Reference: Copperwood Stage 2 TIA – Comment Responses

**COPPERWOOD STAGE 2
TRANSPORTATION IMPACT ASSESSMENT**

DAYTONA URBAN DEVELOPMENT CORP.
City of Lethbridge RELD
COPPERWOOD STAGE II OUTLINE PLAN

Internal Daily Traffic Volumes

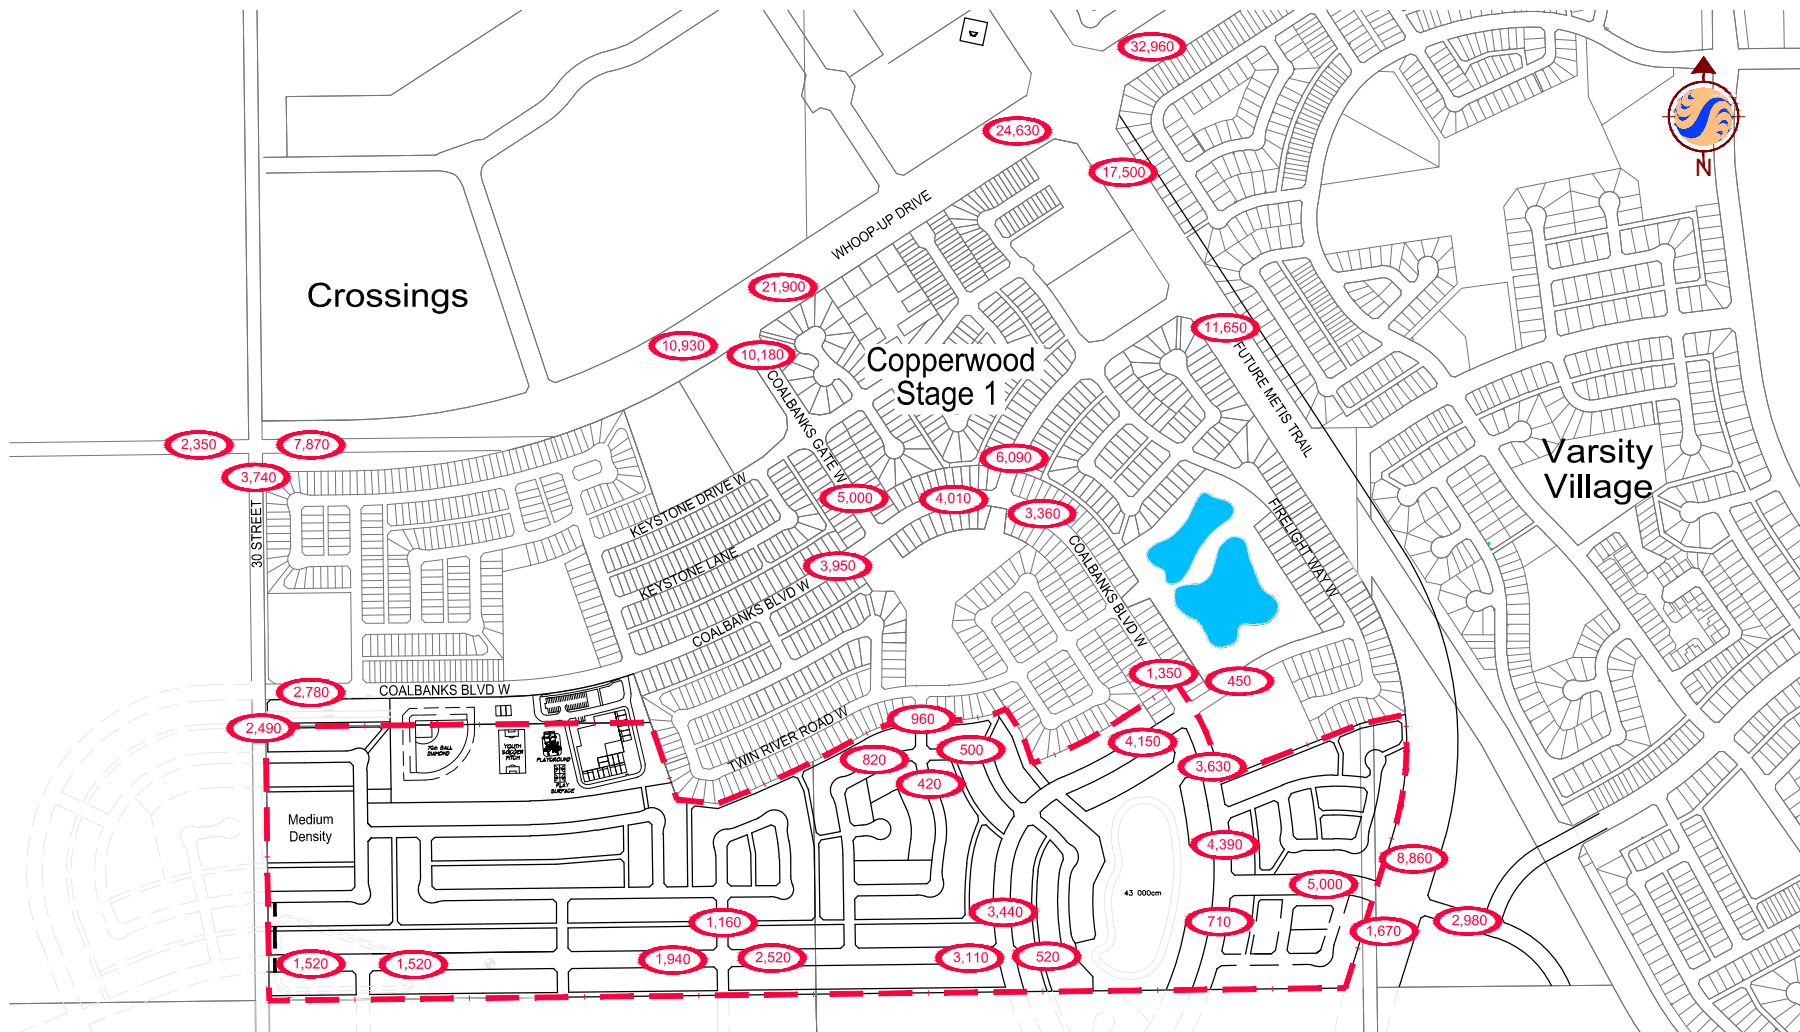
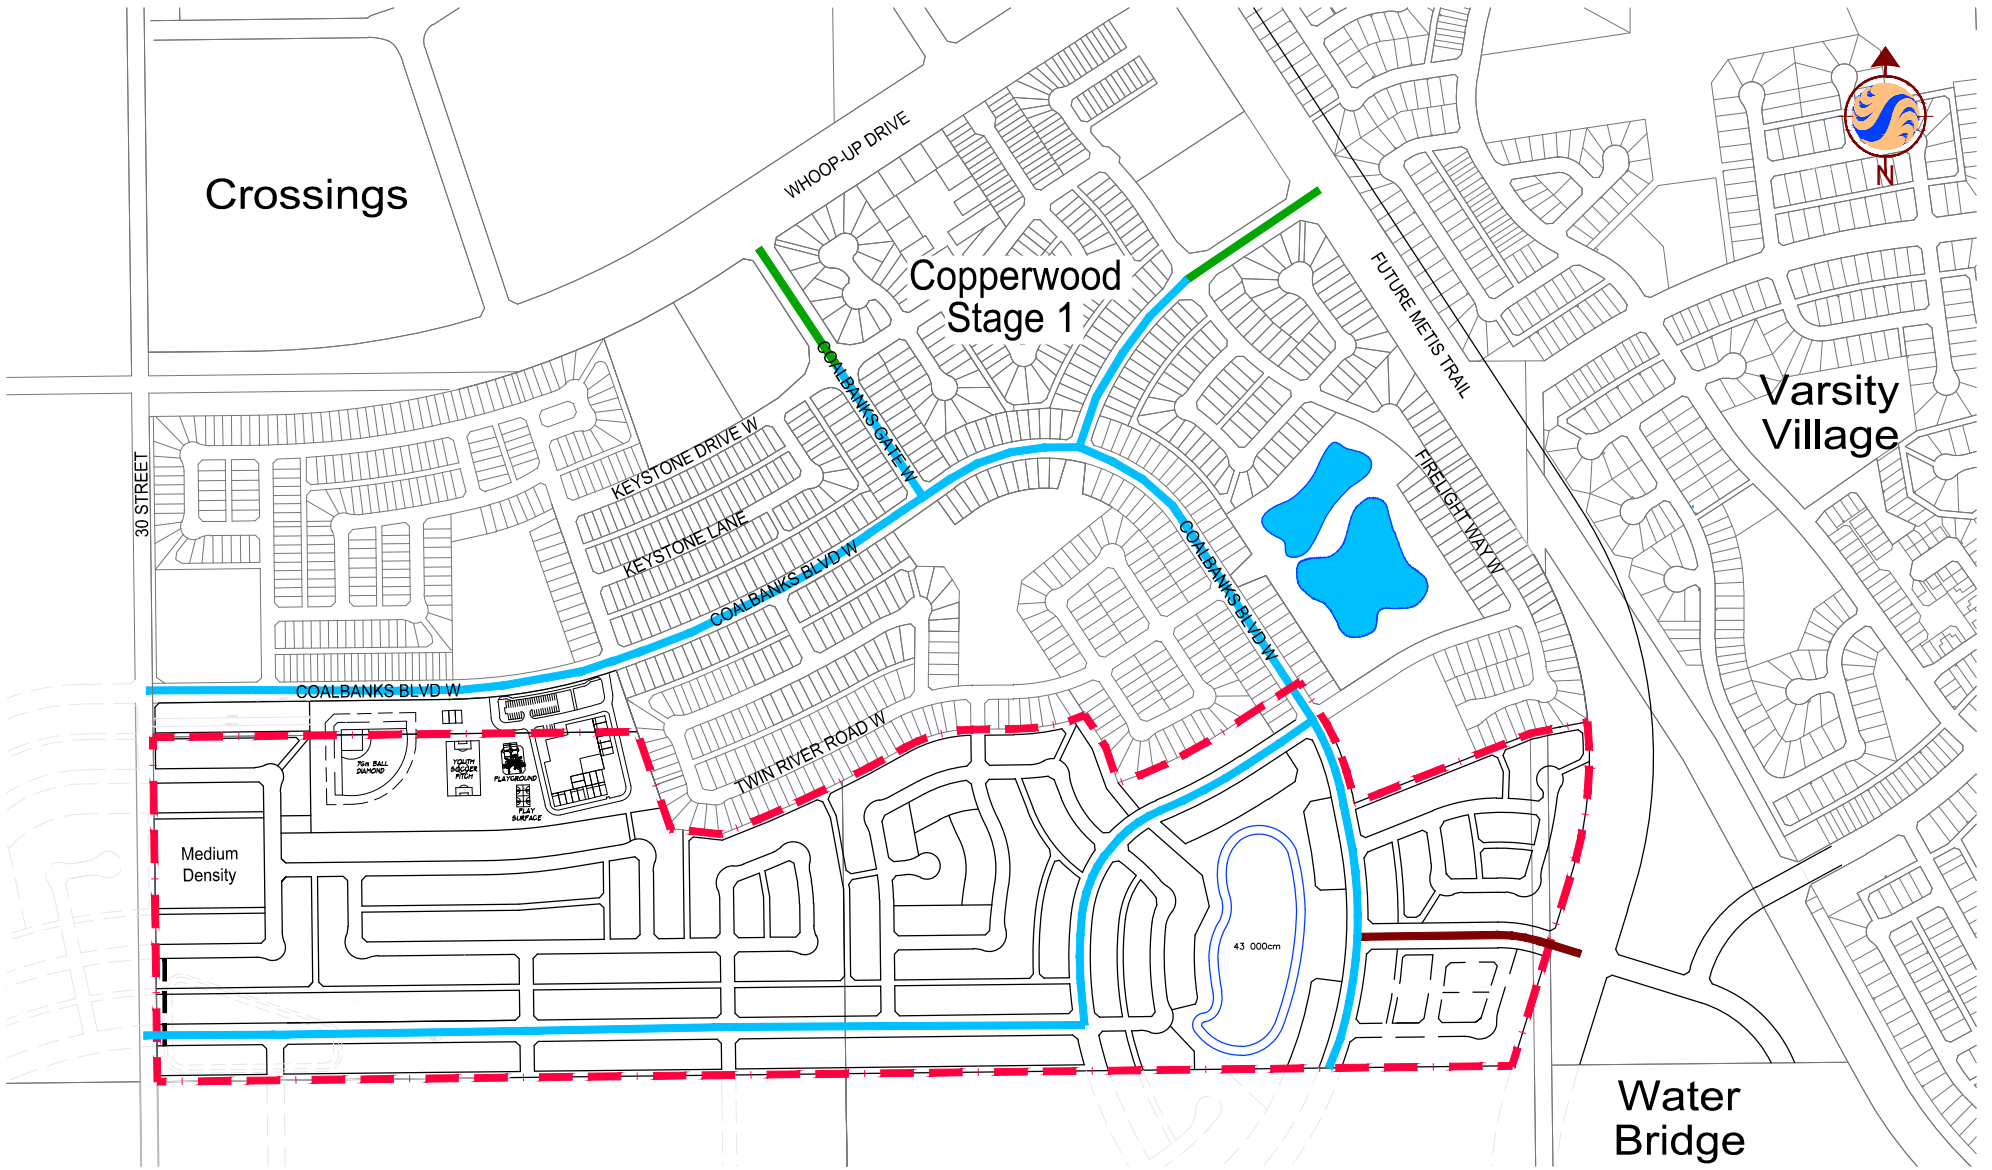
6. City's Comment: *Figure 4.3: I consider the analysis on Copperwood Stage 2 Access/Coalbanks Blvd W (intersection 55) and Metis Trail/Simon Fraser Blvd (Copperwood Stage 2 Access) as interim, since both these intersections will be impacted from lands south of this OP area (not considered in your analysis). We would like roundabouts at these intersections. Please revise this section for Intersection 71 as a roundabout as well.*

7. *City's Comment: Figure 4.3: Make the daily volumes legible (make the dots smaller and may be text smaller or use schematic rather than the drawing as the background).*

Response: The report has been updated to provide the results for all three intersections as both conventional intersections as well as roundabouts. Similar to the original report, the existing intersection (Metis Trail/Coalbanks Link W) has been analyzed for both the background and post-development horizons.

Response: Acknowledged. Figure 4.3 has been revised to more clearly illustrate the daily volumes.
